V2500-A5 SERIES PROPULSION SYSTEM SERVICE BULLETIN

This document transmits Revision 1 to Service Bulletin EV2500-71-0276 and Revision 1 to the Supplement

V2500-ENG-71-0276

ENGINE – ENGINE BUILD UNIT (EBU) – REWORK OF ELECTRICAL HARNESS AND BRACKET ASSEMBLY
TO ACCOMMODATE THE REROUTING OF THE OIL SCAVENGE TUBES

Rework of the Bracket and Fire Detection Harness (System B)
Figure 1, sheet 1 of 3

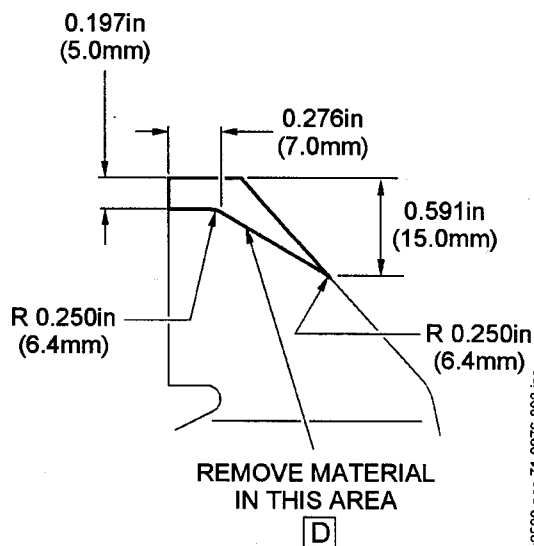
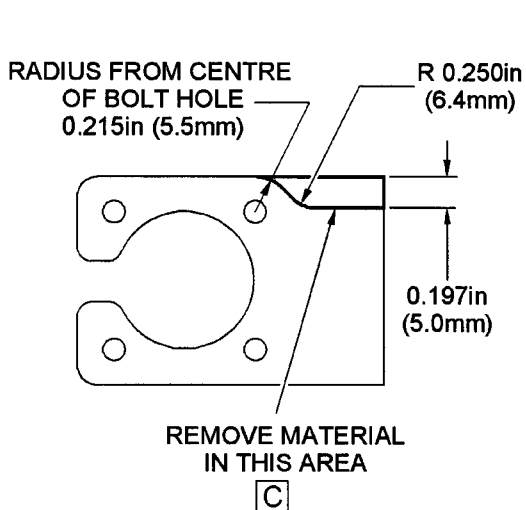
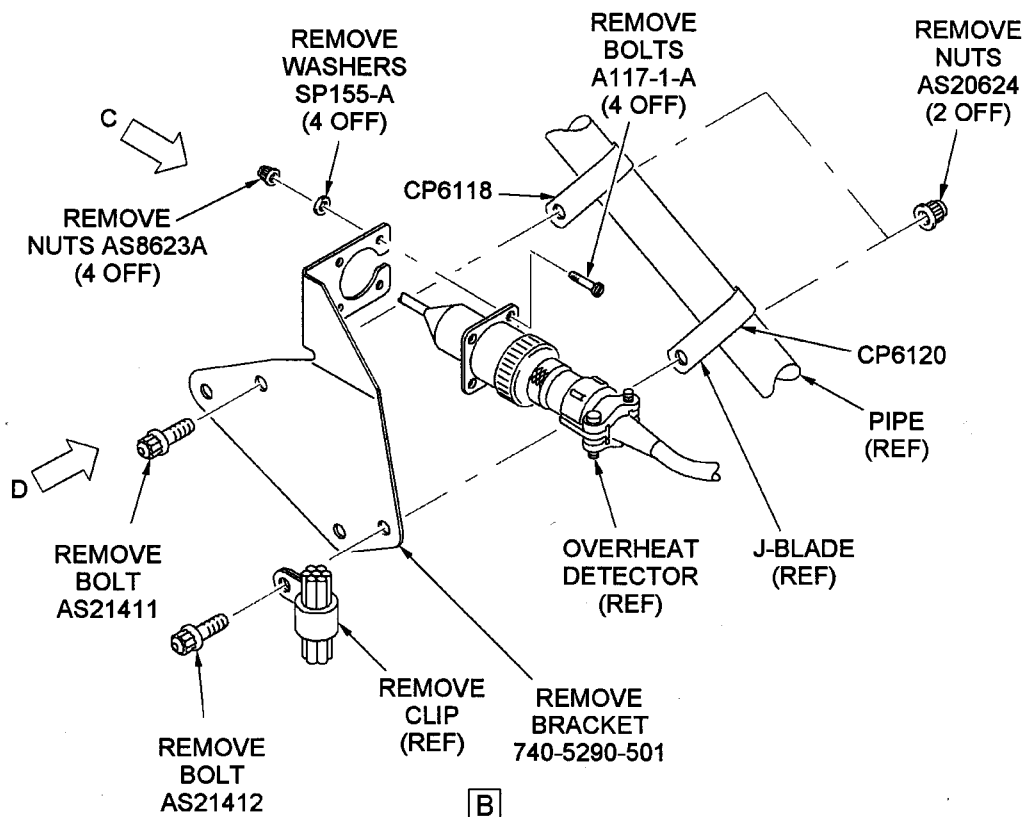
- (1) Find the 740-5290-501 Bracket which attaches to the 745-5862-501 Fire Detection Harness (System B) on the underside of the engine. Refer to Figure 1, Sheet 1 of 3.
- (2) Remove the 740-5290-501 Bracket from the aircraft using the steps that follow:

| (a) Clipping Point CP6118: Remove the upper, aft AS20624 Nut and AS21411 Bolt which attach the 740-5290-501 Bracket to the J-Blade (ref) and Pipe (ref). | Refer to Figure 1, Sheet 1 of 3 and Figure 1, Sheet 2 of 3. |
| (b) Clipping Point CP6118: Remove the lower, aft AS20624 Nut, SP155-D Washer, two AN960C10 Washers and AS21418 Bolt which attach the 740-5290-501 Bracket to the J-Blade (ref) and Pipe (ref). | Refer to Figure 1, Sheet 1 of 3 and Figure 1, Sheet 2 of 3. |
| (c) Clipping Point CP6120: Remove the upper, forward AS20624 Nut, P-Clip (ref) and AS21412 Bolt which attach the 740-5290-501 Bracket to the J-Blade (ref) and Pipe (ref). | Refer to Figure 1, Sheet 1 of 3 and Figure 1, Sheet 2 of 3. |
| (d) Clipping Point CP6120: Remove the lower, forward AS20624 Nut, SP155-D Washer, two AN960C10 Washers and AS21418 Bolt which attach the 740-5290-501 Bracket to the J-Blade (ref) and Pipe (ref). | Refer to Figure 1, Sheet 1 of 3 and Figure 1, Sheet 2 of 3. |
| (e) Remove the four AS8623A Nuts, four SP155-A Washers and four A117-1-A Bolts to detach the 740-5290-501 Bracket from the Overheat Detector (ref). | Refer to Figure 1, Sheet 1 of 3 and Figure 1, Sheet 2 of 3. |

- (a) Clipping Point CP6118: Install the upper, aft AS20624 Nut and AS21411 Bolt to attach the 740-5290-503 Bracket to the J-Blade (ref) and Pipe (ref). Refer to Figure 1, Sheet 1 of 3 and Figure 1, Sheet 3 of 3. Lubricate the Bolts with Engine Oil CoMat 10-039 or CoMat 10-040 prior to installation.

- (b) Install the lower, aft AS20624 Nut, SP155-D Washer, two AN960C10 Washers and AS48022 Bolt to attach the 740-5290-503 Bracket to the J-Blade (ref) and Pipe (ref).

- (c) Clipping Point CP6120: Install the upper, forward AS20624 Nut, P-Clip (ref) and AS21412 Bolt to attach the 740-5290-503 Bracket to the J-Blade (ref) and Pipe (ref).

- (d) Install the lower, forward AS20624 Nut, SP155-D Washer, two AN960C10 Washers and AS48022 Bolt to attach the 740-5290-503 Bracket to the J-Blade (ref) and Pipe (ref).

- (e) Install the four AS8623A Nuts, four SP155-A Washers and four A117-1-A Bolts to attach the 740-5290-503 Bracket to the Overheat Detector (ref).

Rework of the Bracket and Fire Detection Harness (System B)
Figure 1, sheet 2 of 3

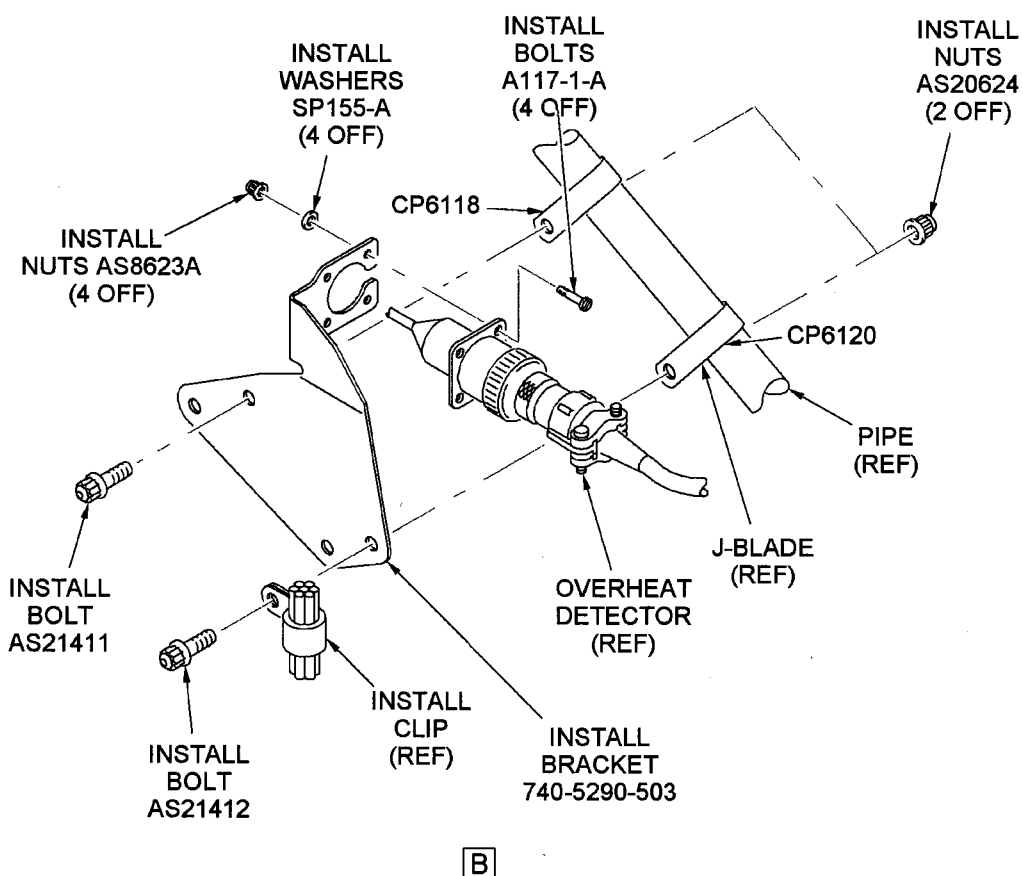
- (a) Use indelible ink pen to mark off the area of the 740-5290-501 Bracket to be reworked. Refer to Figure 1, Sheet 2 of 3.
- (b) Carefully remove the area marked-off in the step above. Refer to Figure 1, Sheet 2 of 3.
- (c) Use vibro-etching to re-identify the Bracket from '740-5290-501' to '740-5290-503'. Refer to Figure 1, Sheet 2 of 3. Re-identify parts as instructed in the Standard Practices/Processes Manual, Task 70-09-00-400-501.
